Comments of TransWest Express LLC on
Topics Discussed during the CPUC and ISO June 20, 2016 Telephone Call to discuss
the California ISO 2016-2017 Transmission
Planning Process, 50% RPS Special Study

California/Regional Resource and Transmission Planning Timeframes

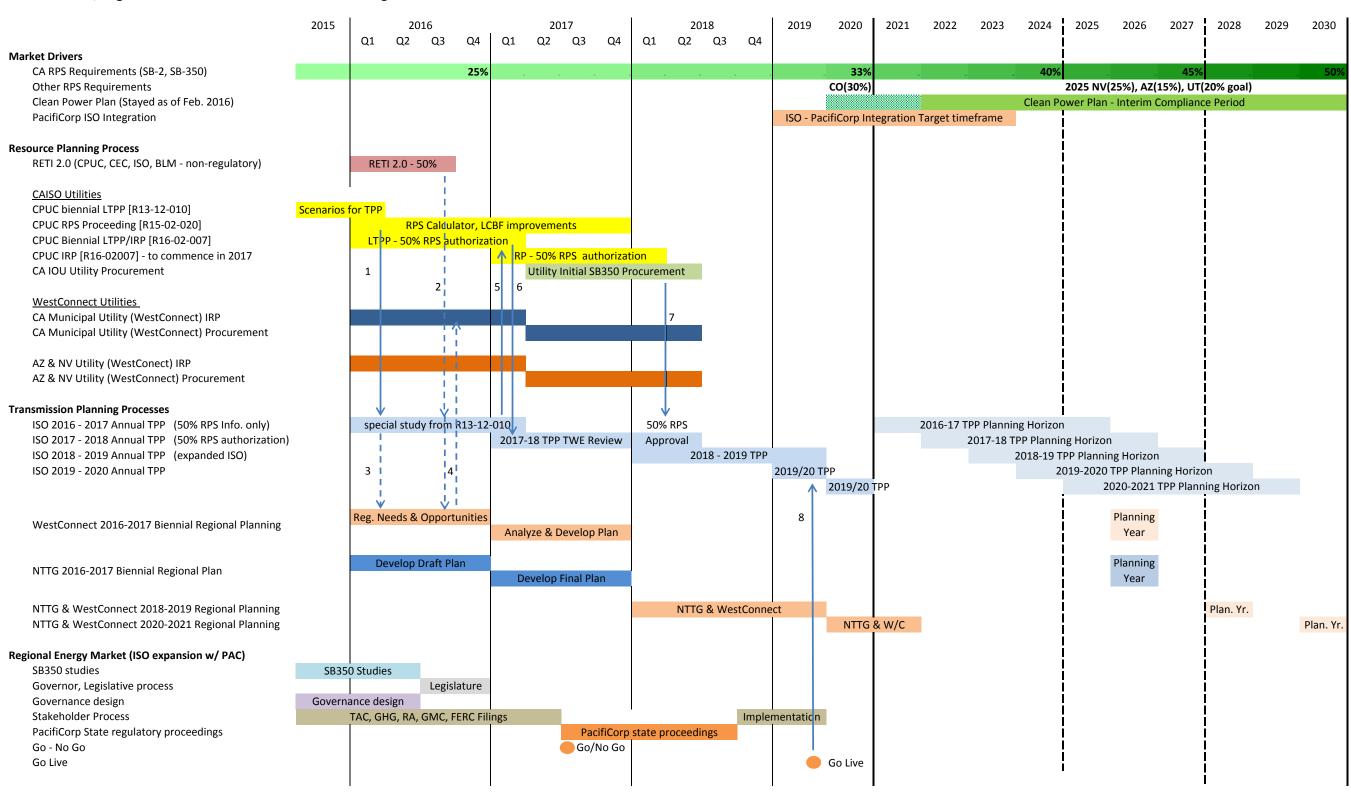
The information from this listing will be helpful as well to inform the generic project information updated in the RPS Calculator as well as needed market information for LSEs. Out-of-state resources, especially ones located in remote areas in Wyoming and New Mexico that require transmission additions cannot file Generator Interconnection Requests with the ISO. Therefore market participants do not have a way to request or to understand the impacts of such a request on the evaluated cost for the resources without the ISO reviewing these within the Special Study. It is quite possible that the RETI 2.0 TTIG and/or the Western Interstate Electric Board will develop such a listing. However the constraints on that process and resources at hand will require the ISO's review and confirmation on the key data.
